MODIFICATION RECOMMENDED

DSO9254A-01

S E R V I C E N O T E

DSO9254A 2.5GHz Digitizing Oscilloscope

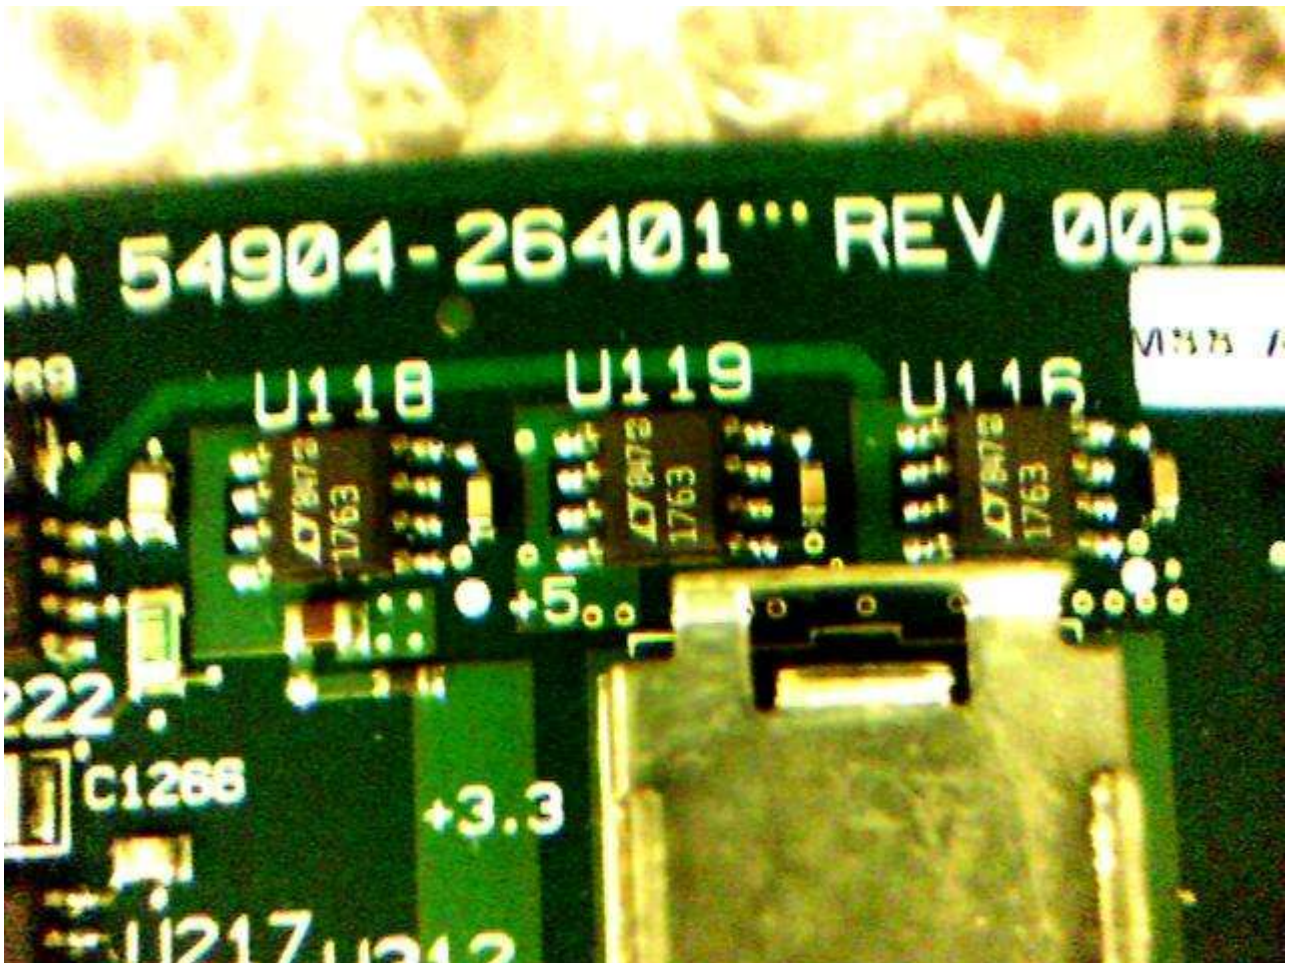
This is a onetime replacement because you are replacing the acquisition board 54901-66501 rev 005 with a later board rev of at least 006. The below picture shows a typical board number with the board rev listed. The board number 5490X-26401 is the raw PC board number. Once the board is loaded with parts and tested, the board number changes to 5490X-66501. The important part of the below picture is that the board rev of 005 is shown. This board must be removed from the scope and returned to SPO. SPO will return the defective board to AMC. You can install a new or refurbished acquisition board in the scope. At the writing of this service note, the new board part number was 54902-66501 and the refurbished part number was 54902-69501. If the board rev is 006 or higher, do not replace the acquisition board with this service note.
